**Date :** 9/3/2012 5:03:18 PM  
**From :** "Bown, Charles W."  
**To :** "'BrianCrawley@nalcenergy.com'"  
**Subject :** Fw: Draft Final report - MHI DG3 review  
**Attachment :** Consolidated DG3 report (final draft).pdf;

# Review of the Muskrat Falls and Labrador Island HVdc Link and the Isolated Island Options

**FINAL DRAFT**

Prepared for:  
Hon. Jerome Kennedy, Q.C.  
The Minister of the Department of Natural Resources  
Government of Newfoundland and Labrador

**Figure 8: Typical HVdc Transmission Guyed Tangent Structures**

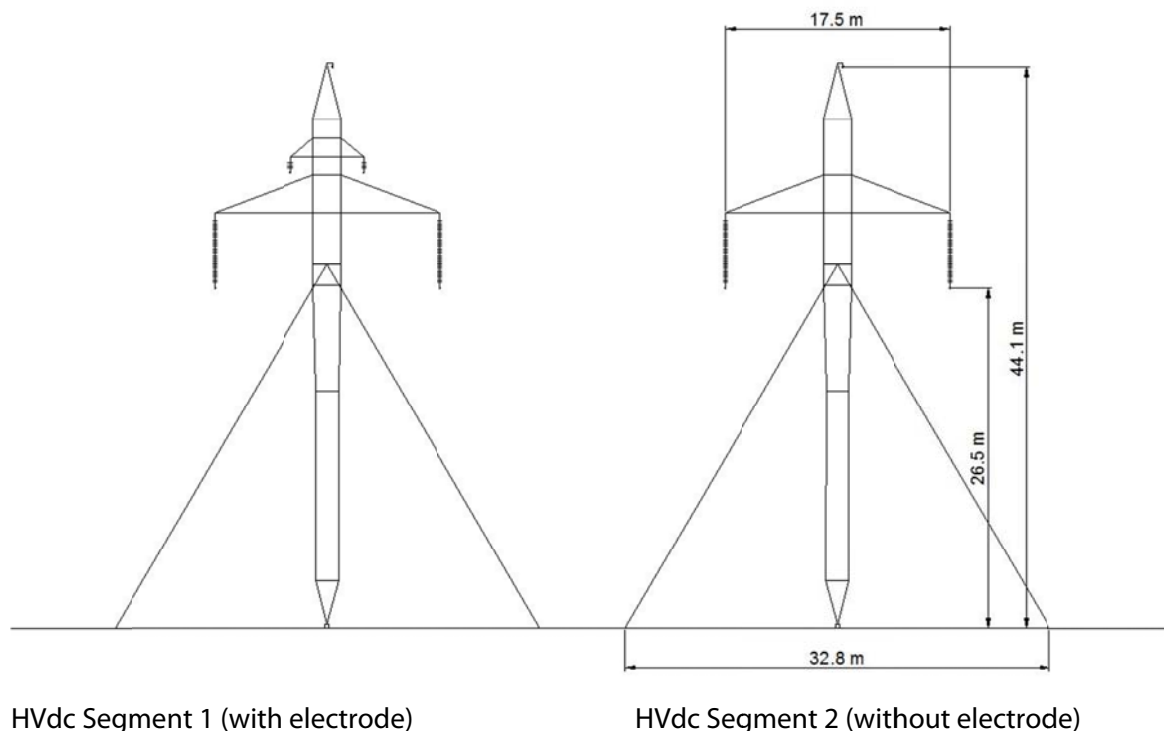
Engineering work is in progress to complete the detailed design for the HVdc line. Nalcor has defined 12 structure families, with a total of 25 structure types<sup>52</sup>, required to economically construct the line. Wherever possible, an effort was made to use common structures in the various loading zones in an effort to minimize the number of unique, custom structures which mitigates design and construction cost.

*Typical guyed tangent tower which comprise approximately 85% of the towers in the Labrador-Island HVdc transmission line.*

Figure 9: Design Spans for Ice Loading

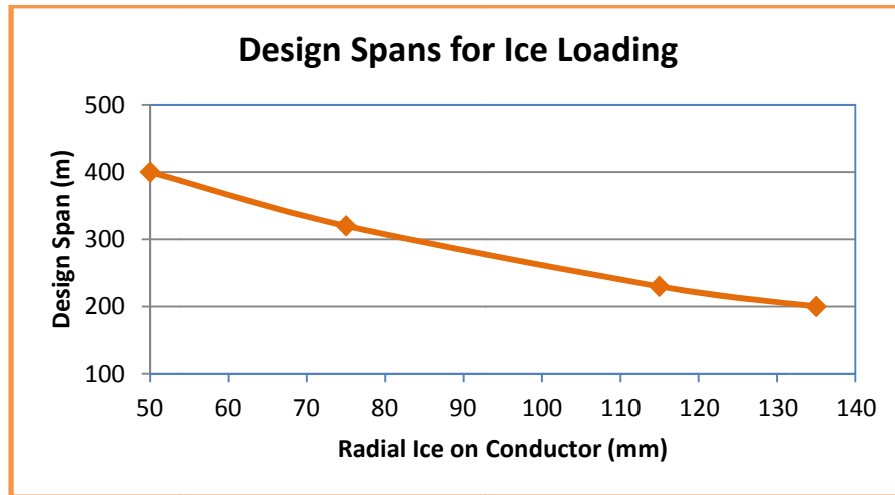
Nalcor's design controlled the various combined ice-and-wind loading to the line structures by reducing or increasing the ruling span in the 16 weather-zone regions. Generally, as the ice-and-wind-combined loading increased, the design ruling span was reduced. This is an acceptable approach to controlling the structure size and weight, and ultimately construction and logistics costs.

***MHI has reviewed the various ice-and-wind loading cases and required structure families and has determined that Nalcor's design approach, given the severity and wide range of weather cases found along the transmission line route, is a reasonable and cost-effective methodology.***
